RE: STAFF REPORT ANALYZING THE MERITS OF TUCSON ELECTRIC
POWER COMPANY'S PROPOSED CONDITIONS MODIFICATION
REGARDING AN EXTENSION OF TIME ON THE CERTIFICATE OF
ENVIRONMENTAL COMPATIBILITY GRANTED IN
DOCKET NO. L-00000C-95-0084

**STAFF REPORT
UTILITIES DIVISION
ARIZONA CORPORATION COMMISSION**

**TUCSON ELECTRIC POWER COMPANY
DOCKET NO. L-00000C-95-0084**

APPLICATION FOR CEC EXPIRATION EXTENSION

Tucson Electric Power Company
Docket No. L-00000C-95-0084
STAFF Exhibit A

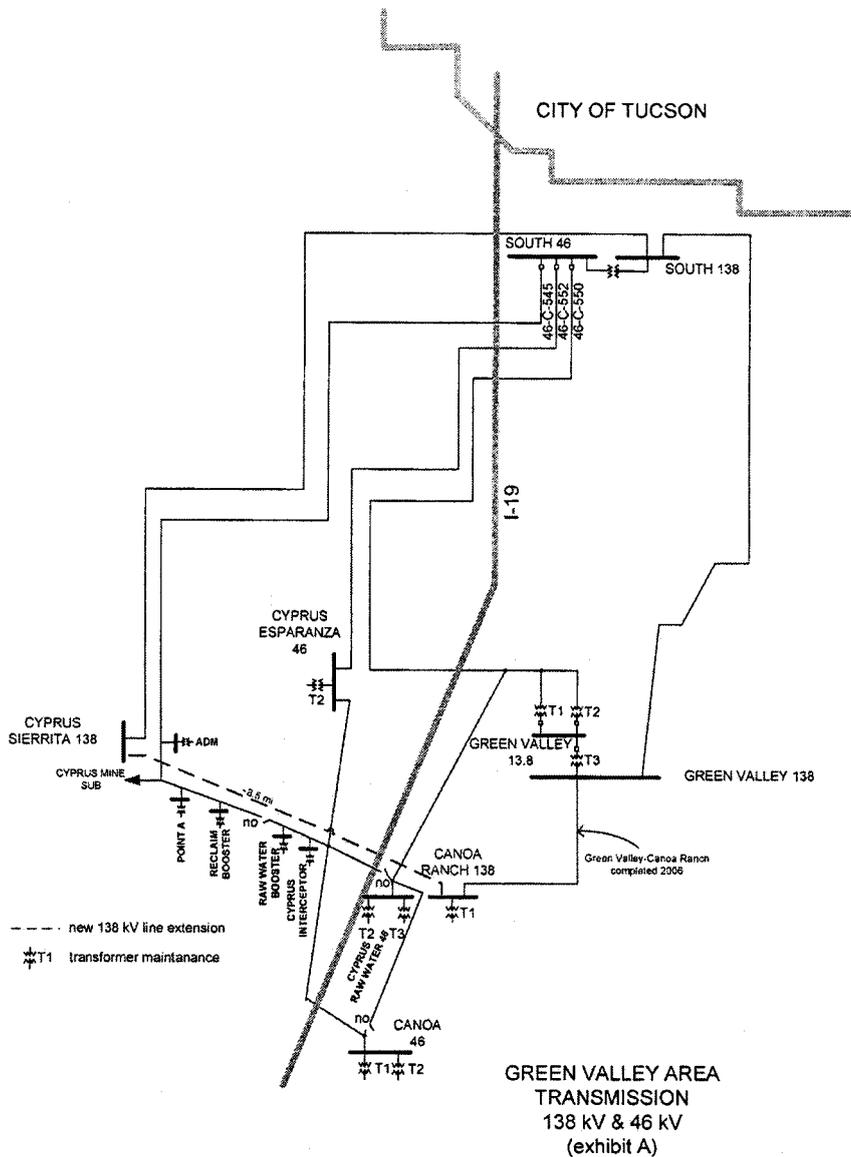
Exhibit A of this report is the latest system diagram of the Green Valley Area 138 kV and 46 kV transmission system reported by TEP. TEP plans to begin using the newly constructed portion of the Phase Two 138 kV line between Green Valley and Cyprus Raw Water Substation to serve a new Canoa Ranch Substation in 2009. Then TEP plans to commence construction of the remainder of the Phase Two 138 kV line between Canoa Ranch and Cyprus Sierrita Substation in 2012 with project completion expected in 2013.

Cyprus Sierrita Substation will continue to be served via a radial 138 kV line from South Substation until Phase Two construction is completed. Similarly, Green Valley and Canoa Ranch Substations will continue to be served via a second radial 138 kV line from South until the Phase Two construction is completed. TEP's 46 kV system provides a means of restoring service to customers for the loss of either radial 138 kV line. Two radial 46 kV lines connected at South Substation provide this system restoration capability at Green Valley, Cyprus Raw Water, Cyprus Esparanza, and Canoa Substations.
